Waters Lake Boulevard Street Dedication Section 5

Median Opening Length

Sienna Municipal Utility District No. 5

LJA Job No. 1415-1605B (6.1)

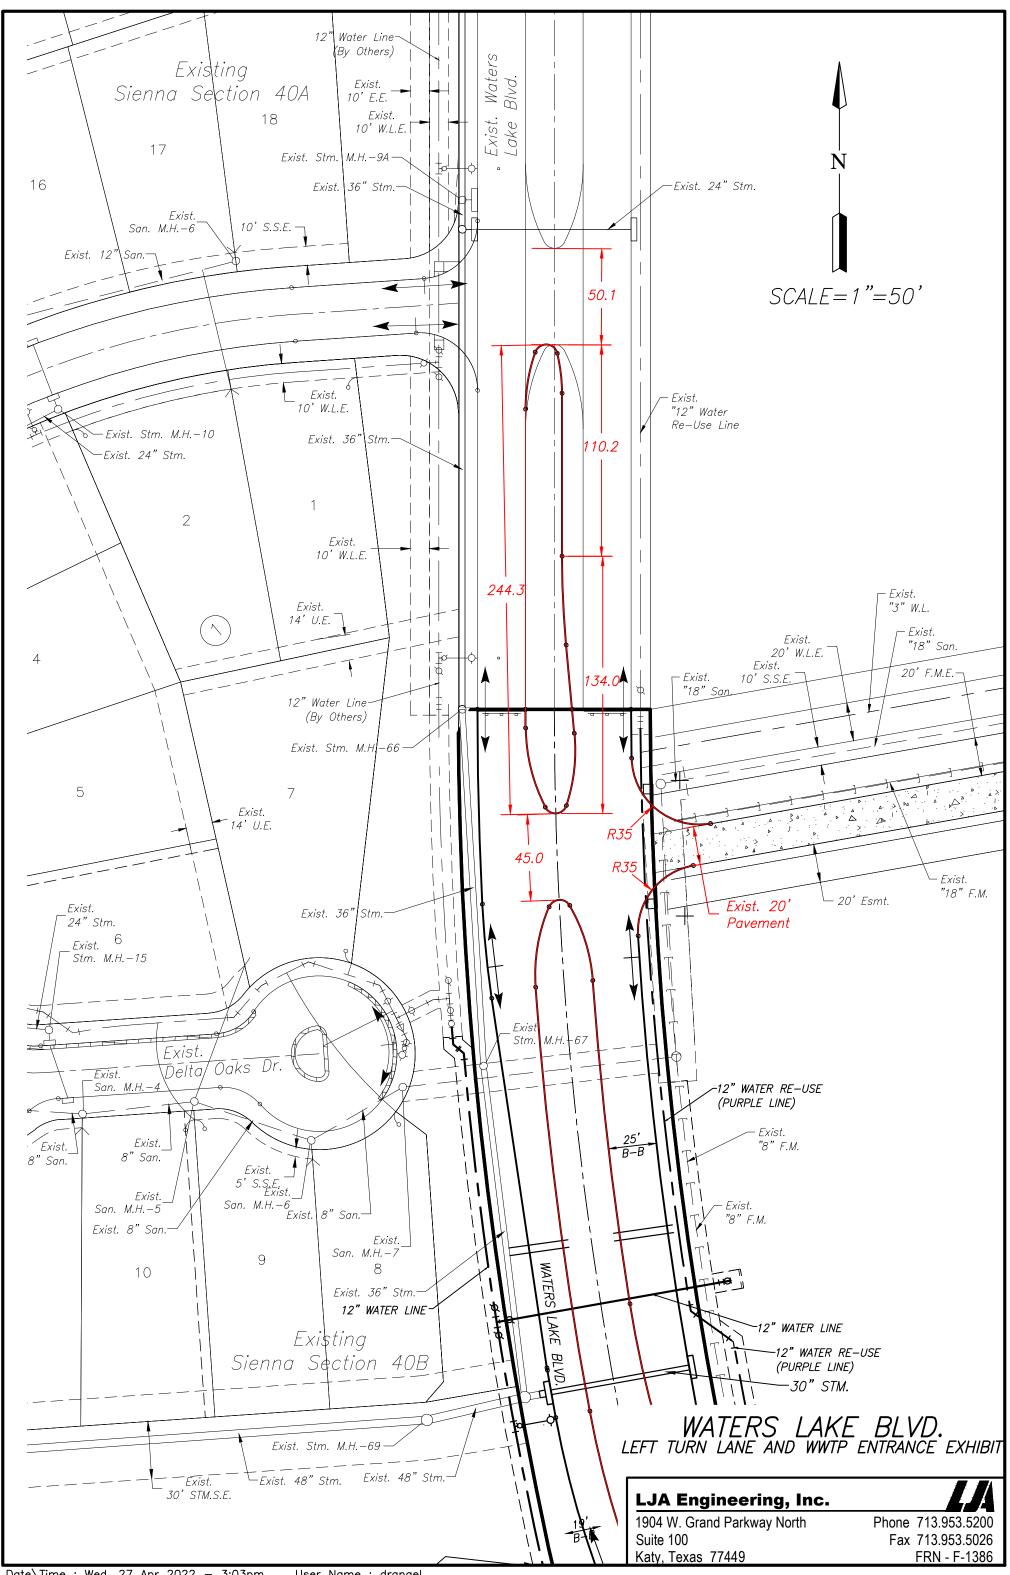
LJA is requesting permission to reduce the required 300 ft median length for thoroughfares to 245 ft at one location along the above referenced roadway. The southern median cut shown at this location is to provide the operator left turn access to the wastewater treatment plant. To the north, there is an existing entry between Sienna Sections 40A and 40B. The median length is directly related to the existing entry points to the north and south. Due to these constraints, the median is proposed to be reduced to 245 ft in order for the openings to line up with the existing roadways. The storage length for the left turn lane has been reduced in this median in order to avoid conflicts with the proposed opening to the south.

Since there are existing constraints at this location, we respectfully request that we be allowed to move forward with the reduced median length at this location. This layout has already been approved by the City of Missouri City as well.
